Sydney Eastern City Planning Panel

SCPP No.	2018SCL026
DA No:	DA/132/2017/C
Street Address	30-36 Dangar Street Randwick
Applicant	Equity Development Management
Owner	Sir Moses Montefiore Jewish Home
Number of submissions	1
Recommendation	Approval
Report By:	William Jones

1. Executive Summary

Figure 3. Insert from proposed Upper Ground Floor for Building F showing example of revised balcony and glass line in conjunction with the approved building envelope.

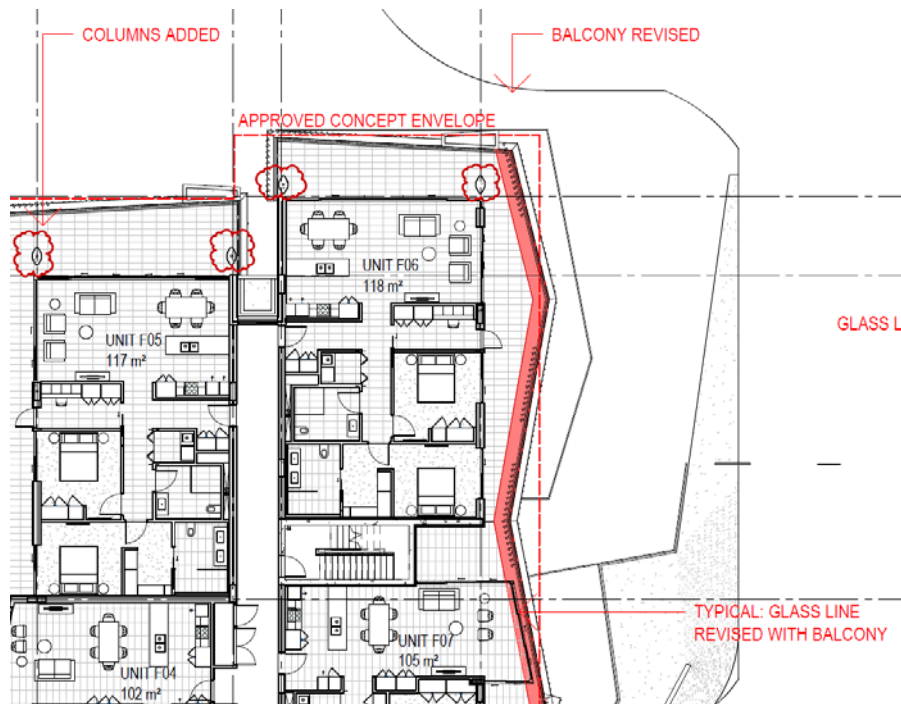
Assessing Officer's Comment: The proposed external changes to the buildings associated with the modified glass lines and extended balconies maintain the articulation of the original buildings as approved and will not result in adverse increased visual bulk or overshadowing. It is noted that some of the approved privacy screens have been deleted from the amended balcony designs. However, given that the building separation between Buildings E and F exceed the minimum requirements stipulated by the Apartment Design Guide in relation to visual privacy, the inclusion of the privacy screens as originally approved is not mandatory to achieve visual privacy.
